AGENDA
PLANNING AND ZONING COMMISSION MEETING
CITY OF CREVE COEUR, MISSOURI
MONDAY, MAY 21, 2018

1. Public Hearing. #18-020: Application to Amend the Conditional Use Permit and Site Development Plan for Parking Lot Expansion and 6,421 Gallery/Building Addition for Congregation B'nai Amoona at 324 S. Mason Road

**APPLICATION TO PLANNING AND ZONING COMMISSION
#18-020 APPLICATION TO AMEND THE CONDITIONAL USE PERMIT
AND SITE DEVELOPMENT PLAN FOR PARKING LOT EXPANSION AND
6,421 GALLERY/BUILDING ADDITION FOR CONGREGATION B'NAI
AMOONA AT 324 S. MASON ROAD**

FOR THE PLANNING AND ZONING COMMISSION MEETING OF: Monday,
May 21, 2018 at 6:30 PM

EXISTING SITE
COVERAGE PLAN

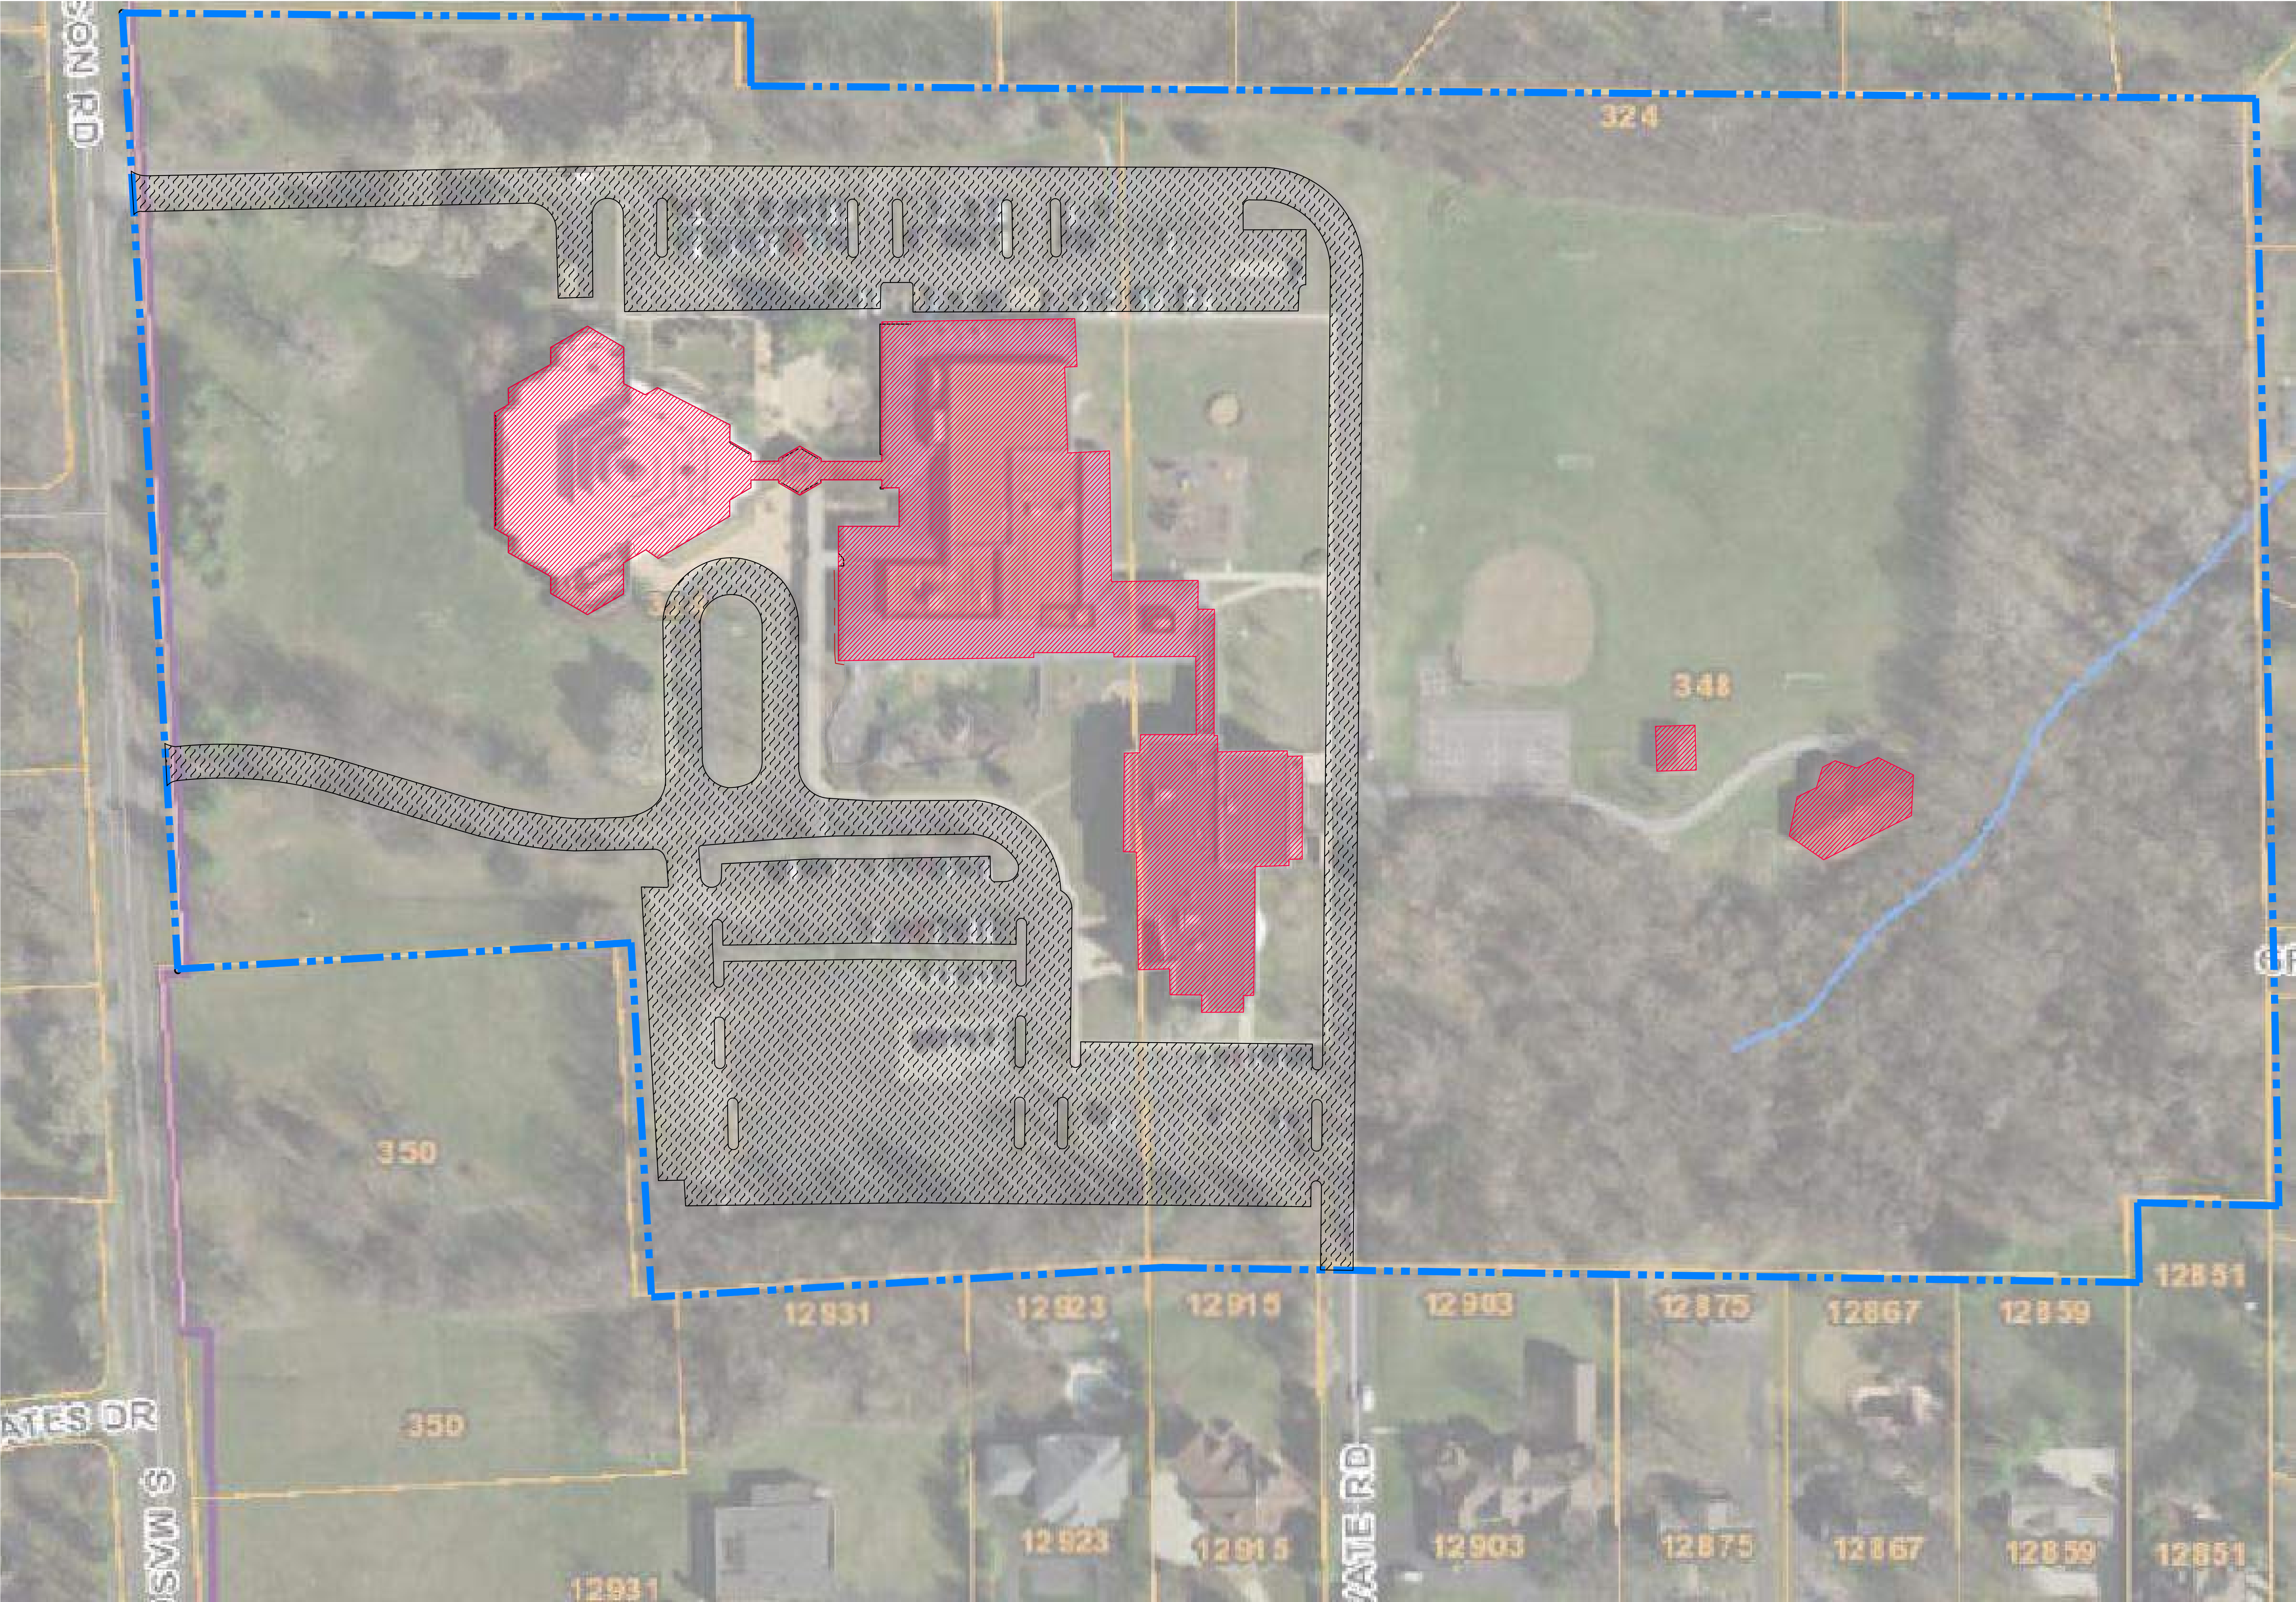
on the site. Section 405.1080 requires site development plan review for a conditional use permit, and any new impermeable surfaces of over 5,000 square feet. The new 6,421 sq. ft. gallery addition connecting the sanctuary and the educational building, and parking lot addition for 72 parking spaces will increase the overall site coverage from 23.28% to 25.05%, or by 22,542 sq. ft., thus requiring a new conditional use permit and site development plan.

3. The Site Development Plan shall be provided to include the property of 350 S. Mason Road, and the calculations shall be revised with this new area.
4. The Site Development Plan shall be amended to extend the sidewalk from the new parking area to the existing sidewalk along S. Mason Road and all new sidewalks shall comply with Section 405.730 Sidewalks of the Zoning Ordinance.
